# **Geotechnical Investigation**

## **Proposed Mixed-Use Development**

Wellings of Stittsville – Phase 2, 3, and 4  
20 Cedarow Court  
Ottawa, Ontario

Report PG4772-1 Revision 5 dated May 29, 2023

<b>Scale:</b>	N.T.S.	<b>Date:</b>	02/2023
<b>Drawn by:</b>	YA	<b>Report No.:</b>	PG4772-MEMO.05
<b>Checked by:</b>	NP	<b>Drawing No.:</b>	<b>FIGURE 1</b>
<b>Approved by:</b>	FA	<b>Revision No.:</b>	2

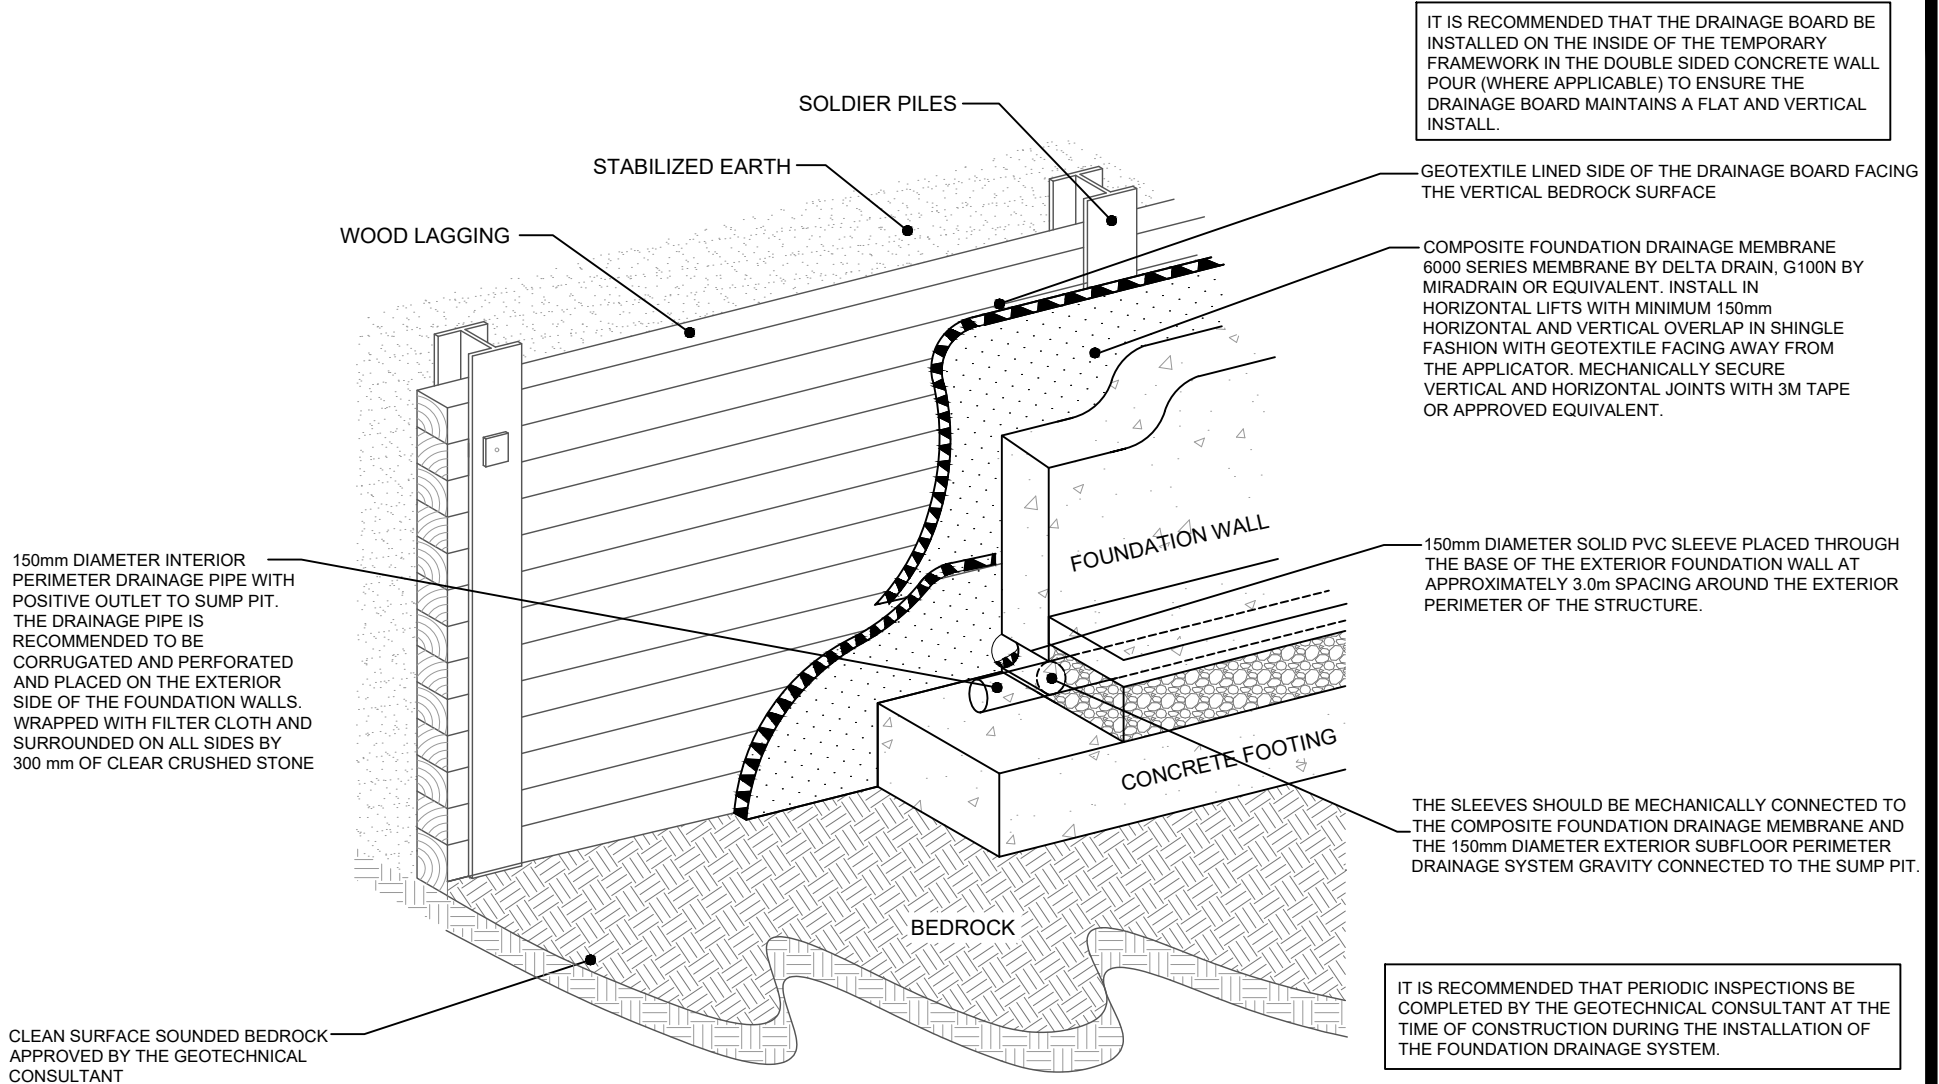
- ❑ Blind-Sided Pour: Where the foundation walls are constructed using a blind-sided pour and the drainage board is fastened directly to the shoring system/bedrock, the horizontal overlaps should be completed such that the top of the lower sheet of drainage board is underlying the bottom of the upper sheet. Refer to Figure 1 - Foundation Drainage System - Blind-Side Pour.

Scale:	N.T.S.	Date:	03/2023
Drawn by:	NFRV	Report No.:	PG4772
Checked by:	NP	Drawing No.:	<b>FIGURE 3</b>
Approved by:	DJG	Revision No.:

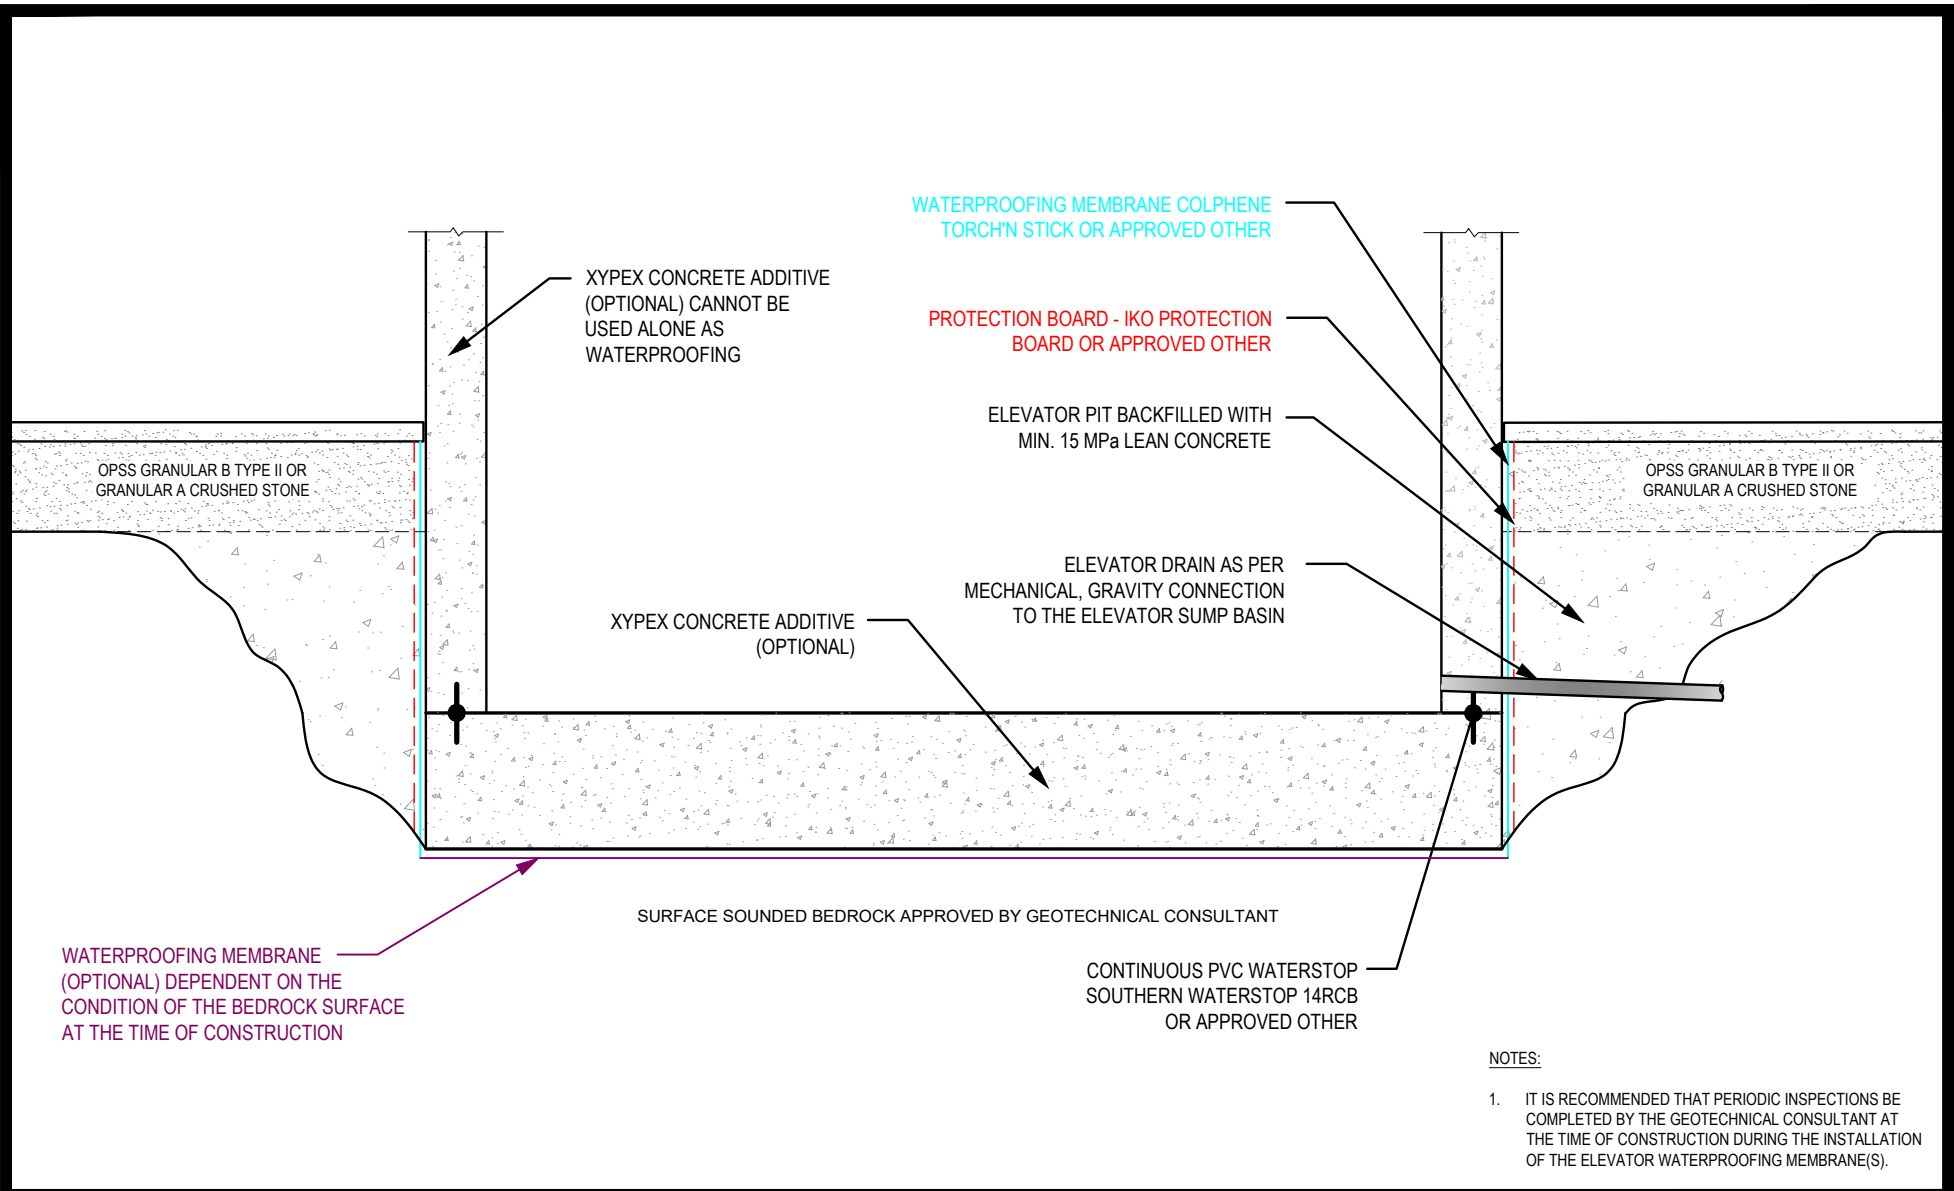
- ❑ It is critical that the composite foundation drainage board is extended in a suitable manner through this transition zone to maintain the long-term performance of the foundation drainage system. It is recommended that the composite foundation drainage board be extended a minimum of 0.6 m beyond the limits of the temporary shoring system where a transition from blind side to double sided formwork is anticipated. As a result, the contractor should be prepared to provide supplemental temporary formwork to ensure this transition is completed in a suitable manner.

- ❑ The purpose of additional custom formwork is to provide a suitable surface on which to maintain the vertical continuity and application of the foundation drainage system across the transition zone from blind-side to double-sided pours. Based on our experience, the additional formwork will be required in areas where the bedrock/overburden interface has an unsuitable quantity of voids, jagged surfaces and/or fractures from blasting and bedrock removal procedures. This custom formwork typically consists of suitably prepared plywood, rigid insulation, or other concrete formwork materials as procured by the formwork contractor which is cut and sized to match the contours of the bedrock/overburden interface. This additional effort and material by the formwork contractor will mitigate the risks associated with over-pouring the foundation beyond the overburden/bedrock interface and with pouring concrete onto the system bridging gaps and voids. Lastly, carrying out this measure will ensure that the foundation drainage system is installed in a relatively flat and vertical fashion.

- ❑ It is **NOT** recommended to fold the composite foundation drainage board to accommodate temporary formwork and the placement of concrete at the transition zone. It is therefore recommended that the contractor modifies temporary forms to match the contour of the surface which the formwork will be placed upon (i.e., temporary shoring system) and secure the drainage board against the inside of the temporary forms.

- ❑ Since the bulk of the custom formwork will most likely remain in place, the foundation drainage board must extend a minimum of 1 m above the horizontal and vertical extent of the custom formwork and onto the inside of the prefabricated formwork. Once the foundation wall has been poured and the modified temporary formwork has been removed, the exposed portion of the composite foundation drainage board can be overlapped in a shingle fashion in accordance with the manufacturer's specifications and in general conformance with our geotechnical recommendations.

The above-noted recommendations are further illustrated in Figure 3 – Foundation Drainage System Transition from Blind Side to Double Sided Formwork at the South Excavation Face, attached to the current memorandum.

Scale:	N.T.S.	Date:	02/2023
Drawn by:	YA	Report No.:	PG4772-MEMO.05
Checked by:	NP	Drawing No.:	<b>FIGURE 4</b>
Approved by:	FA	Revision No.:

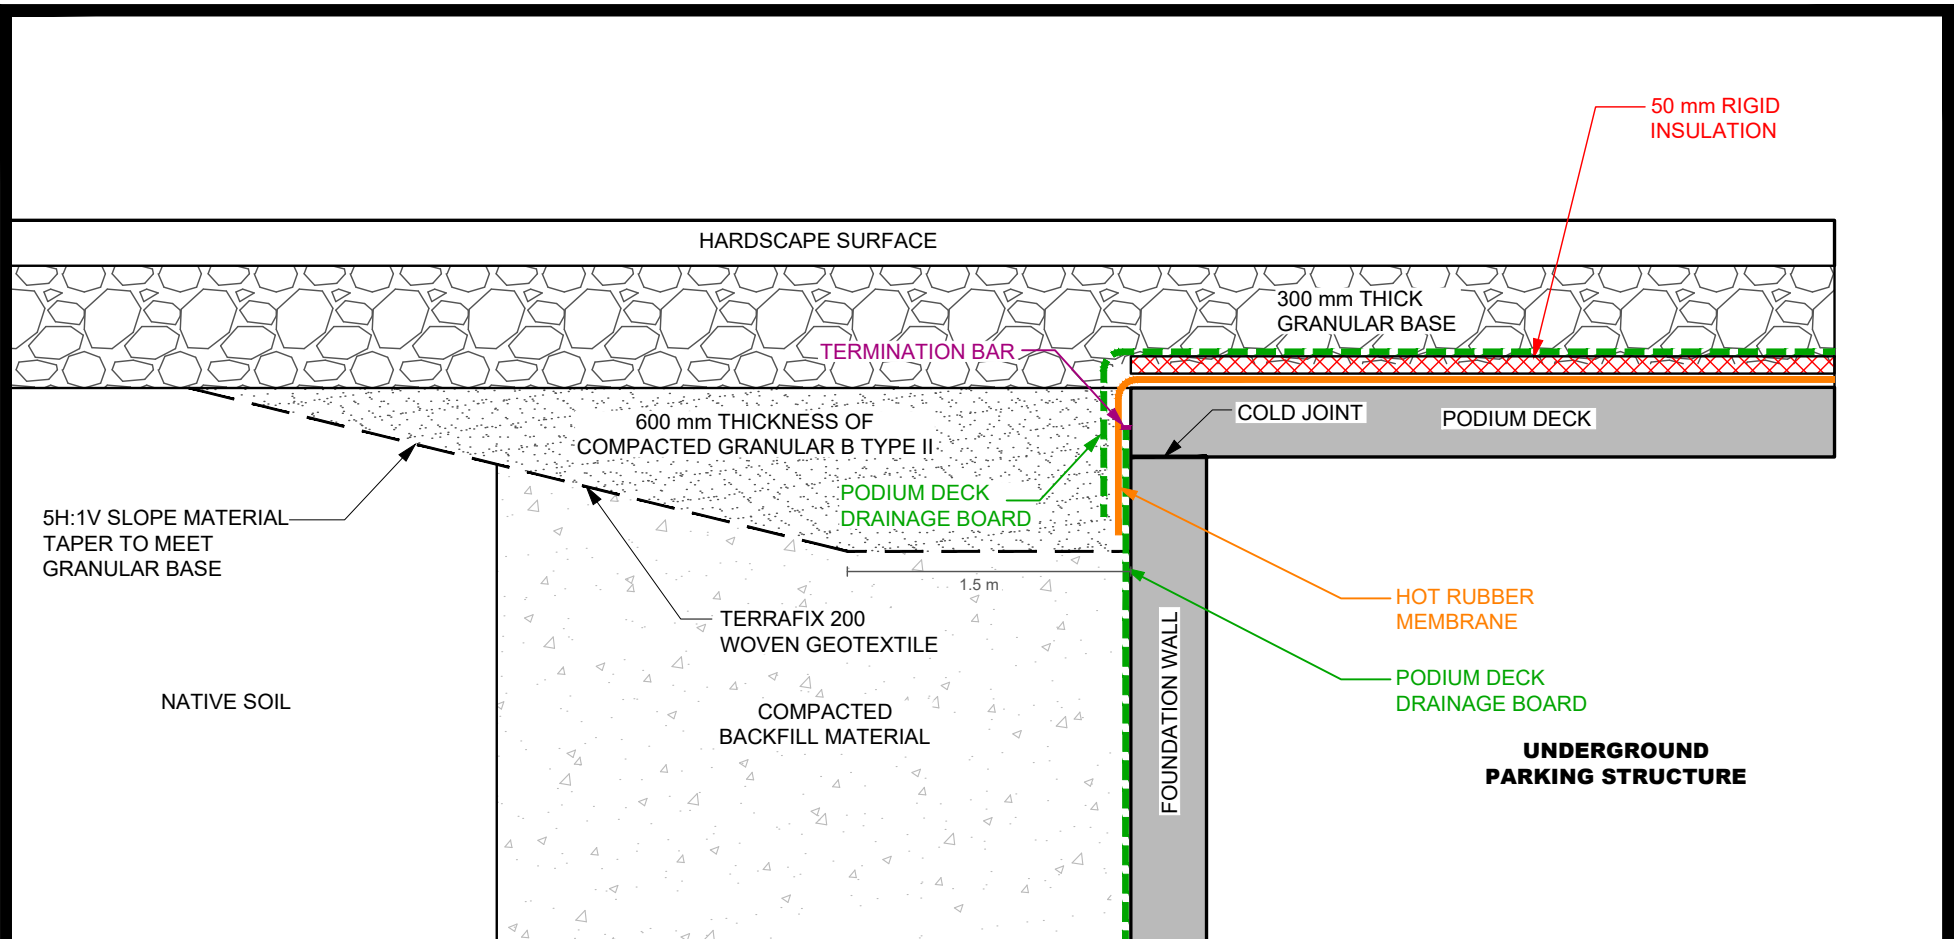
- ❑ A Xypex additive can be used in the concrete mix of the elevator shaft walls and slabs to provide a secondary waterproofing measure. This is optional and **cannot** be used as a standalone waterproofing for the elevator pits.

- ❑ Reference should be made to Figure 4 - Waterproofing System for Elevator, for specific details of the elevator waterproofing attached to the current memorandum.

It should be noted that the current detail of the elevator pit waterproofing system proposed by Chmiel Architects on above noted architectural drawings has been reviewed by Paterson and it is considered acceptable from a geotechnical perspective.
